UNITED STATES
DEPARTMENT OF THE INTERIOR
BUREAU OF LAND MANAGEMENT

FORM APPROVED
OMB NO. 1004-0135
Expires: July 31, 2010**SUNDRY NOTICES AND REPORTS ON WELLS**
*Do not use this form for proposals to drill or to re-enter an abandoned well. Use form 3160-3 (APD) for such proposals.***SUBMIT IN TRIPLICATE - Other instructions on reverse side.**

Apache proposes to change the casing/cement/BOP program as shown below.

AAO Federal #25

Eddy County, New Mexico
Sec 1, T18S, R27E
AAO Federal #25
Design #3
Quote 140591

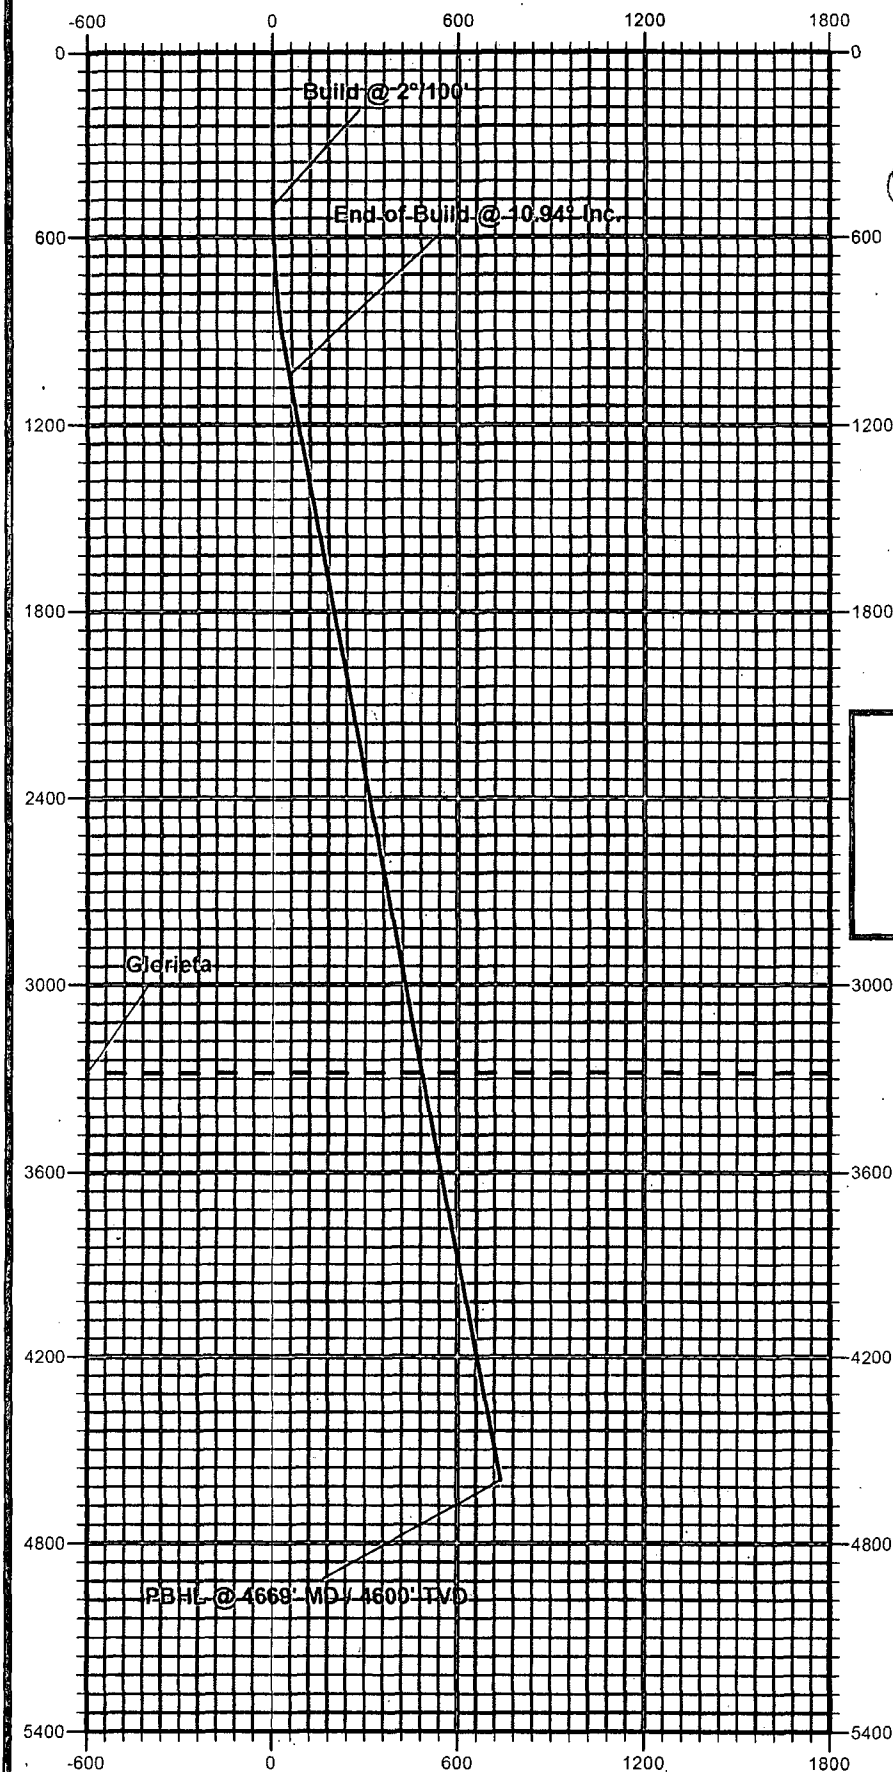
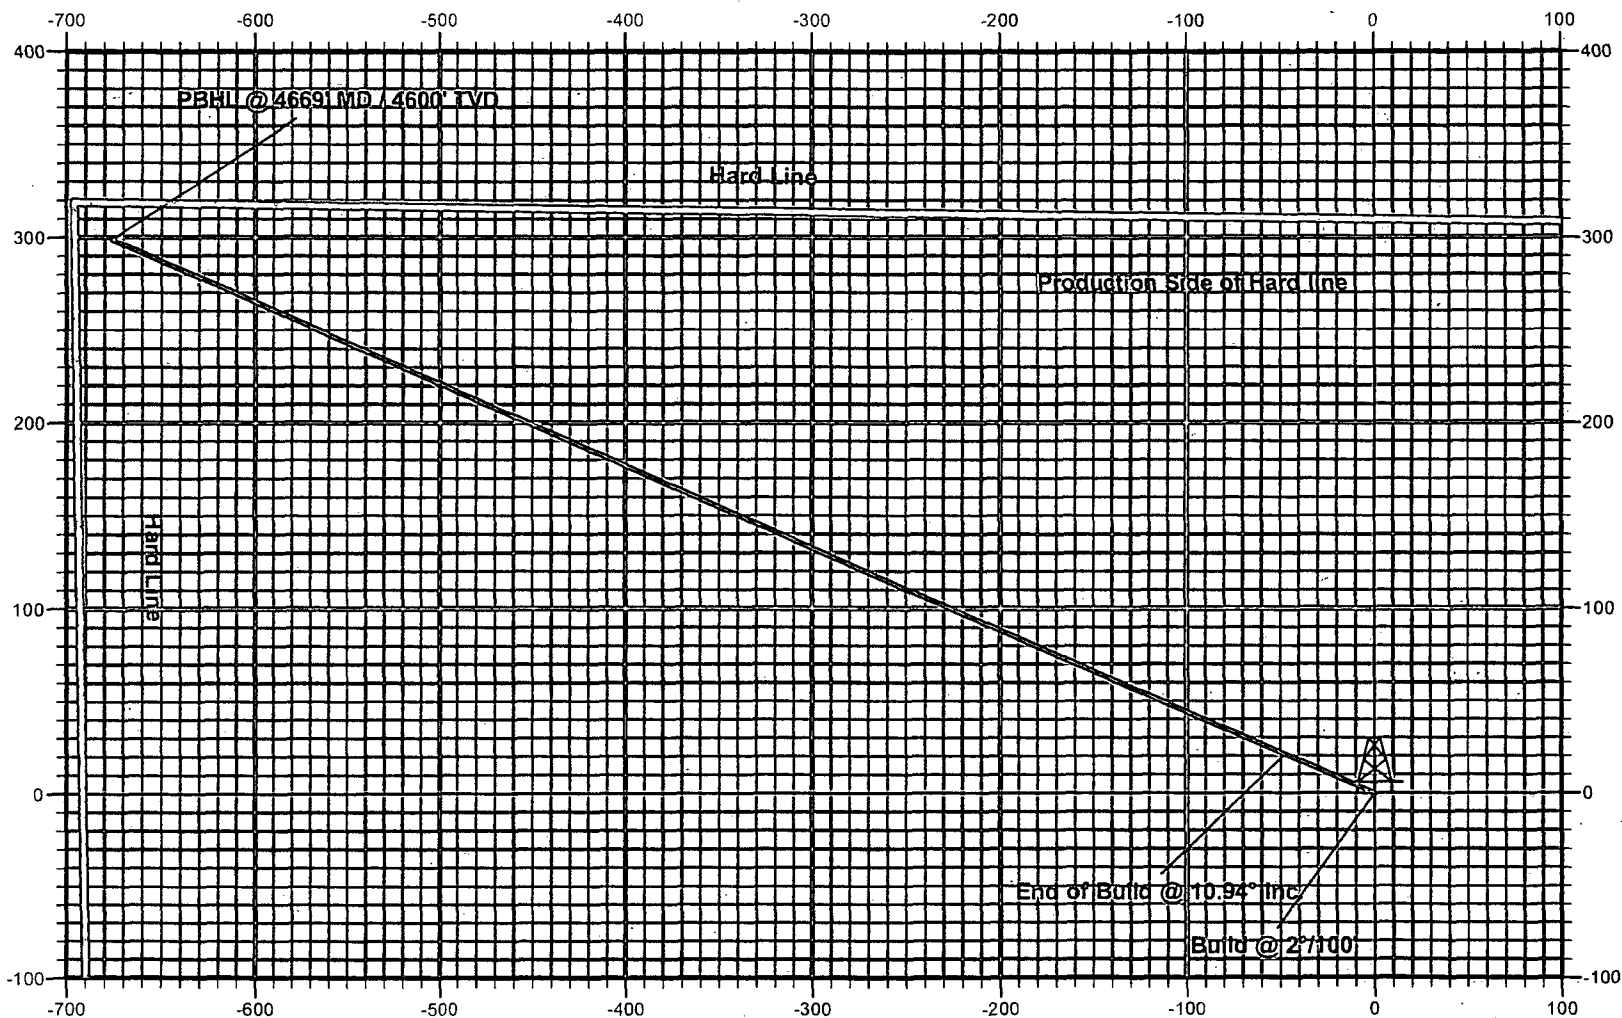
Rest of CMT PROGRAM & PROPOSED CONTROL EQUIP on attachment due to lack of space. Have also added a new directional plan.
